UNITED STATES PATENT AND TRADEMARK OFFICE

APPLICATION NO.	FILING DATE	FIRST NAMED INVENTOR	ATTORNEY DOCKET NO.	CONFIRMATION NO.
10/036,303	12/28/2001	Frank Hawley	ACT-307DVA	2755

Office Action Summary	Application No. 10/036,303	Applicant(s) HAWLEY ET AL.	
	Examiner Anh D. Mai	Art Unit 2814

DETAILED ACTION

FIG. 1A

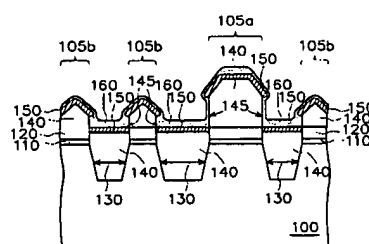
To disprove the Applicants assertion that an article having a same number should be the same. Attention is directed to the U.S Publication No. 20020137305. In the drawing Fig. 1A, below, all active region are designate 105b and all of the trenches are designate 130.

Are the active region (105b) the same size ?

Are the trenches (130) the same size and uniform cross-section ?

U.S. Patent Jun. 1, 1999 Sheet 7 of 7 5,909,628

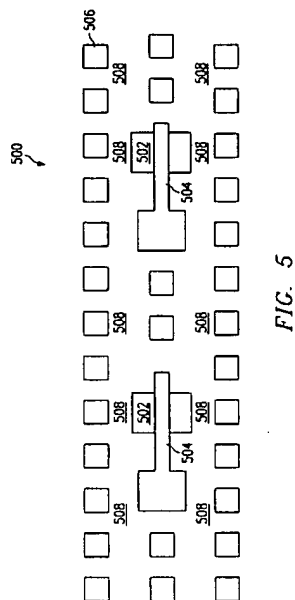
With respect to the declaration, as clearly indicated previously, the declaration had been considered. However, it is not effective because the uniform cross-section is not a must since trenches that isolate an active region can be different in shapes and sizes. (See Mehta '063). To further elaborate that point, Applicant is urged to review U.S. Patent No. 5,909,628, with Fig. 5 is included below.

The trenches (having a same number 508) that surround active region (502) do not seem to be the same in size and of course, do not seem to be: **must have uniform cross-section**.
